# ERRATA SHEET

**Date:** 2008 Nov 07  
**Document Release:** Version 1.2  
**Device Affected:** P89LPC921

Figure 1: Flowchart ICP Global Erase

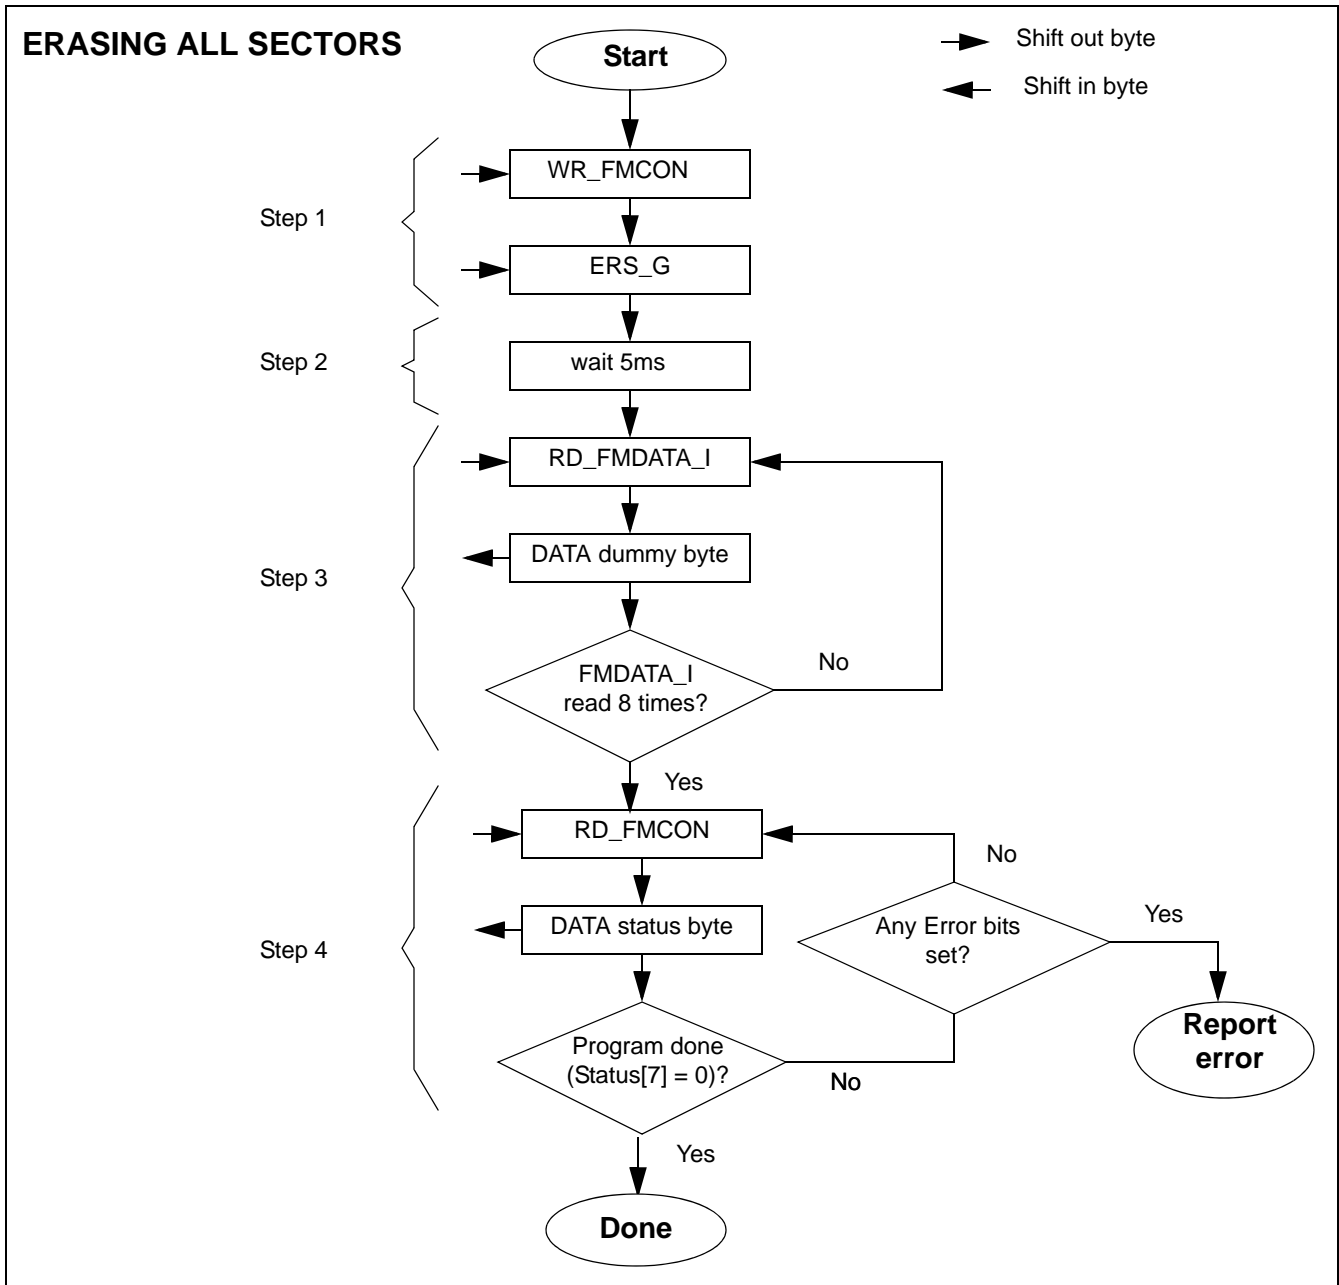
**Problem:** When giving the Erase Global command through the ICP interface the LPC921 will not clear the busy flag and stay busy forever.

**Workaround:** The workaround can be done in 4 steps:

Step 1: Shift out the WR\_FMCON command followed by the Erase Global opcode.

Step 2: Wait 5ms.

Step 3: Do 8 dummy reads with the RD\_FMDATA\_I command.

Step 4: Read FMCON until the busy flag gets cleared.

Please also see figure 1 on the following page.
